9/21/2004 12:24:10 /eagle/EFI/V3.0/megasquirtavr.brd

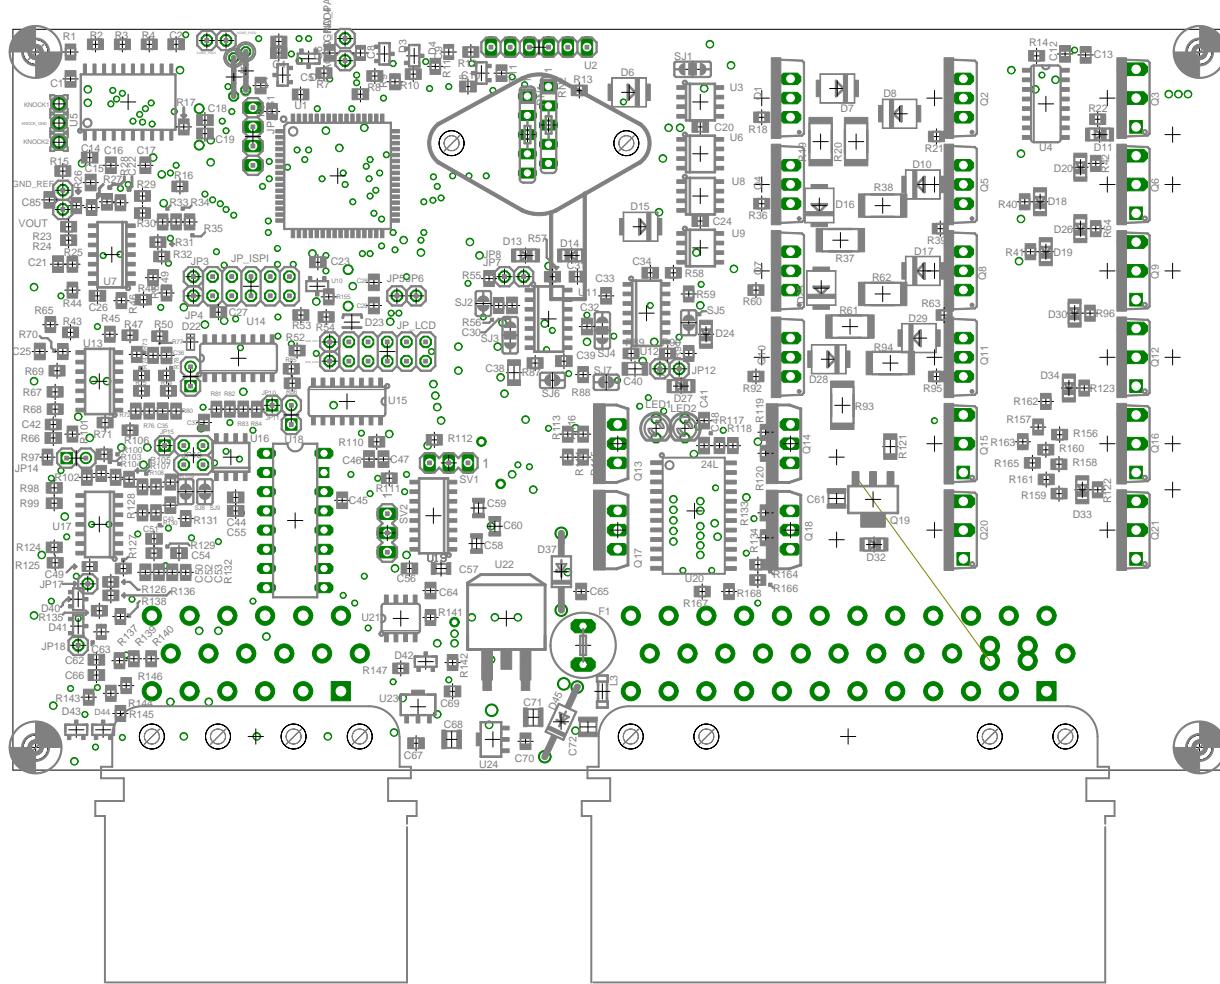
0.04 trace =3A at 30C overtemp

Minimum trace separation at 500V is 1.8mm

But we have solder mask and professionally manufactured boards, we don't need 1.8mm

Investigate protective paint.
